Application No. G G 5812Permit No. G G 6726

Application No. G 5812
Permit No. G 6726

We received your letter of February 21, 1980 regarding your intention to reduce the usage under your permit G6726 to 50 acres of land to be irrigated rather than the 120 acres you filed on. There is no form for this purpose. We will automatically reduce the acreage upon completion of the final proof survey when they find the reduced amount of use.

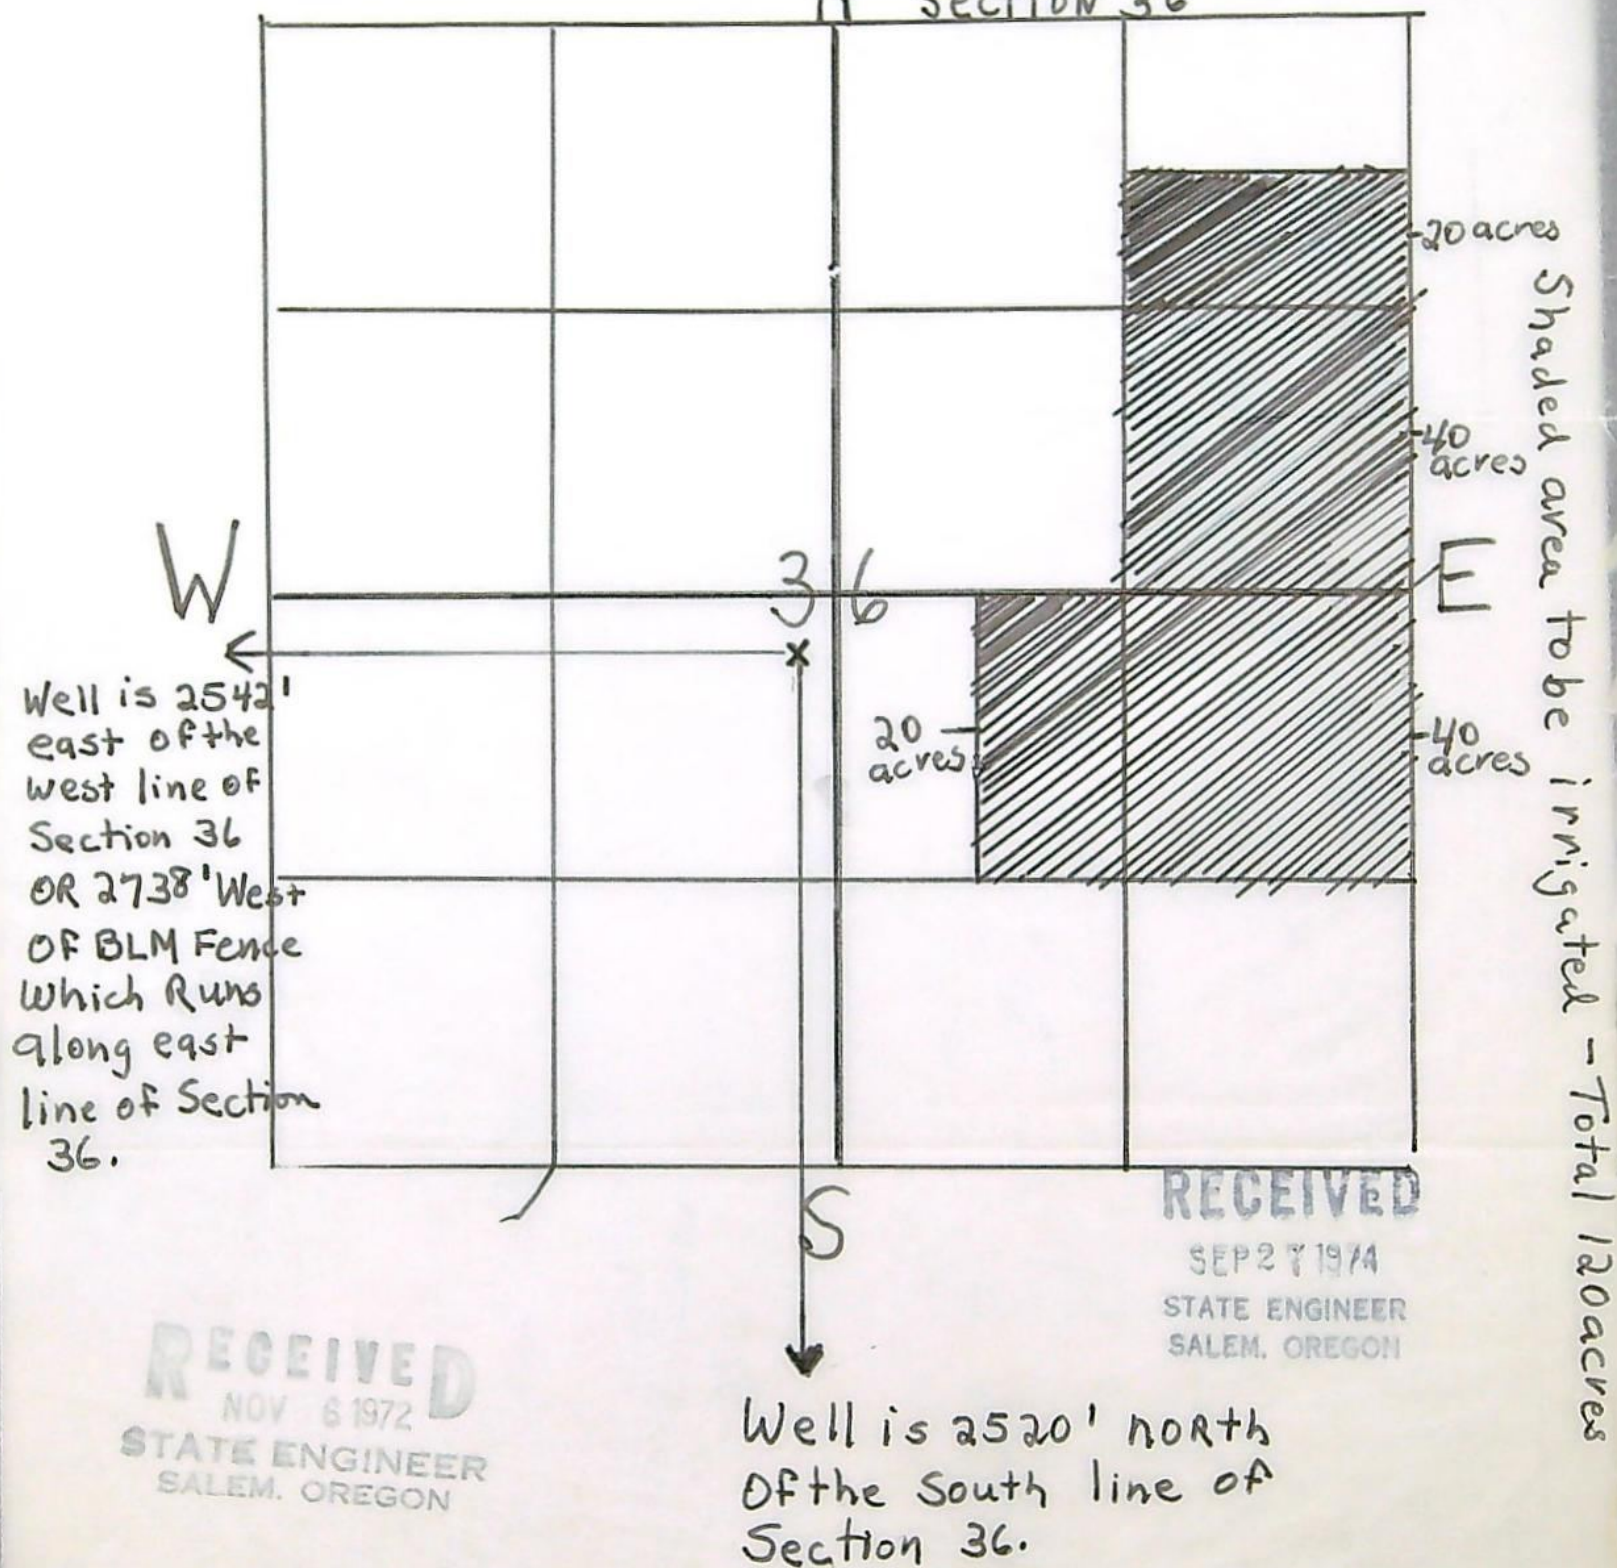
Log and bond were filed on Dec. 20, 1972. The
well was not constructed in conformance with well
standards and must be repaired. Recommend that
permit not be issued until completion of required
repairs.

no response from the landowner. Hold permit.

well sealed. Recommend issuance of permit.

Fields, Oregon
TWP. 40 S., RNG. 35 E.W.M.

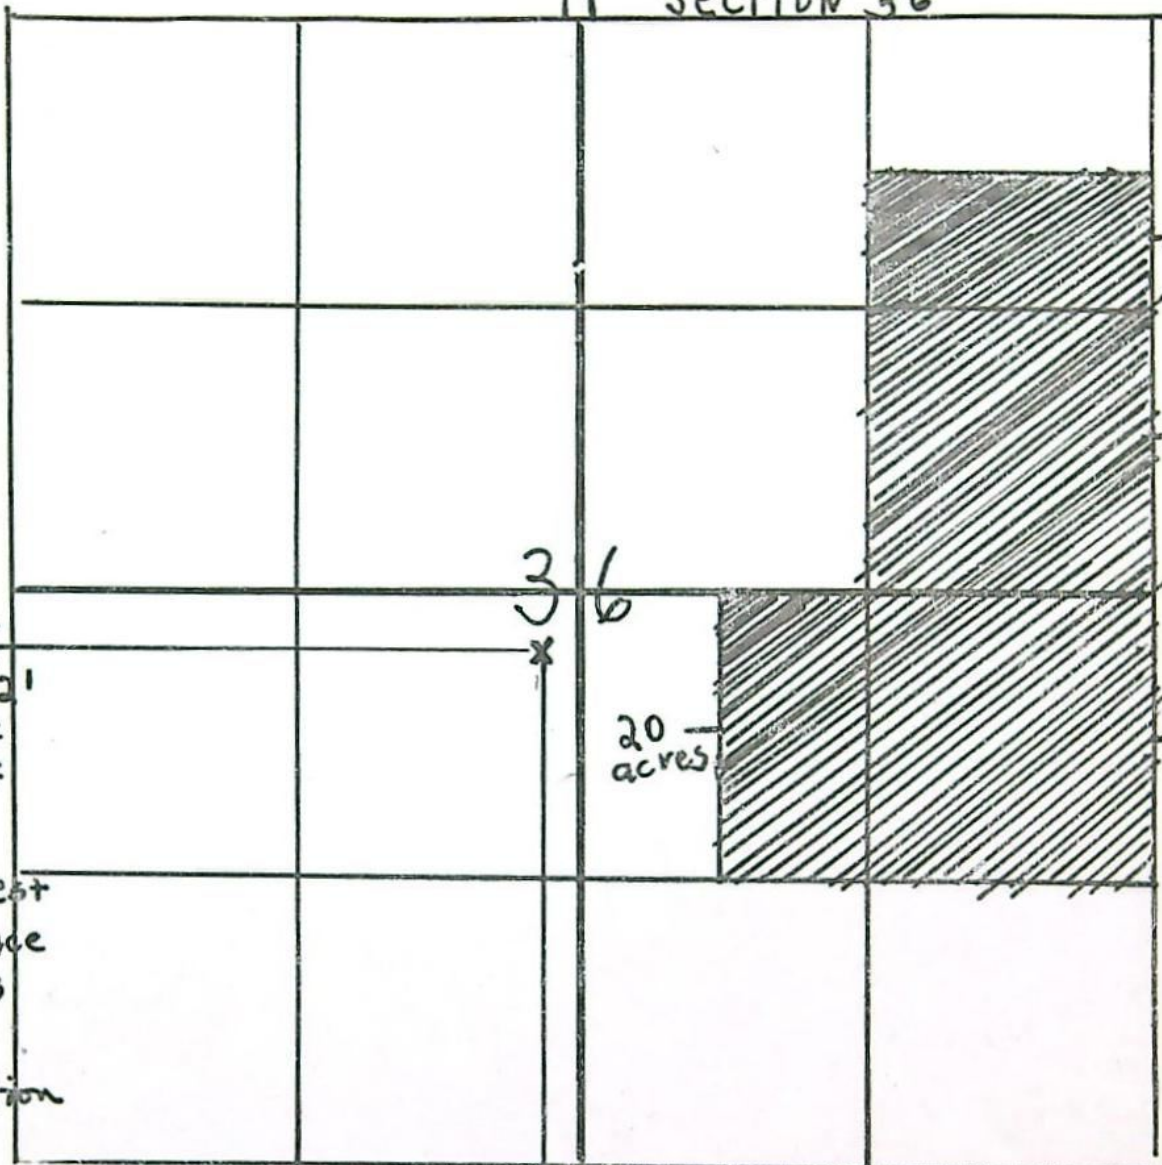
The location of your well must be further located, on line 5 of item 4 of your application, as being within a forty acre tract of Section 36, Township 40 South, Range 35 East, W.M. Based on the description of the location of your well as given in this item and shown on your map, this would be the NE $\frac{1}{4}$ SW $\frac{1}{4}$ of Section 36. If you agree, please amend your application accordingly.

The government survey corner, listed in Item Number 4, to which the well is referenced does not agree with the information given on the map. If the map is correct, the government survey corner should be labeled the Southwest corner of Section 36 rather than the Northeast corner of the Southwest quarter of Section 36. It is also necessary to further describe the location of the well as being within a forty-acre tract and if the well is located correctly on the map, line five should be completed by listing the NE $\frac{1}{4}$ SW $\frac{1}{4}$ of Section 36, Township 40 South, Range 35 East, W. M.

The map of your proposed project must be prepared in black ink. For clarification, the scale to which the map has been drawn must also be included on the map, along with inserting the number of acres to be irrigated within the hatchured area for each quarter-quarter section. It is necessary that this data correspond with the information that is given in Item Number 12 of the application.
